# ADA Curb Ramp New Construction Inspection Form (Parallel)

NW Main

23885.56

NW Lenox

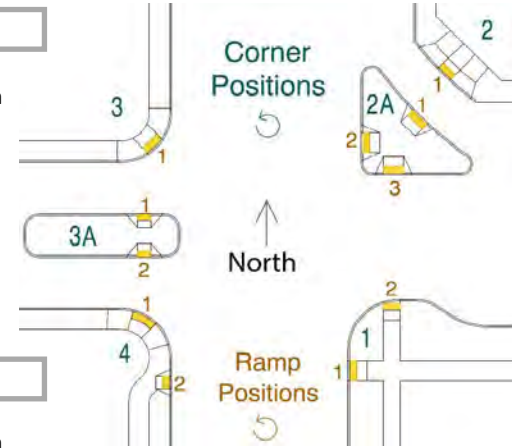
☐ 9.7  $\leq 8.3\%$  ☐  $> 8.3\%$  ☒

DWS IITD Fails Turn and RR 1, ICRR 2
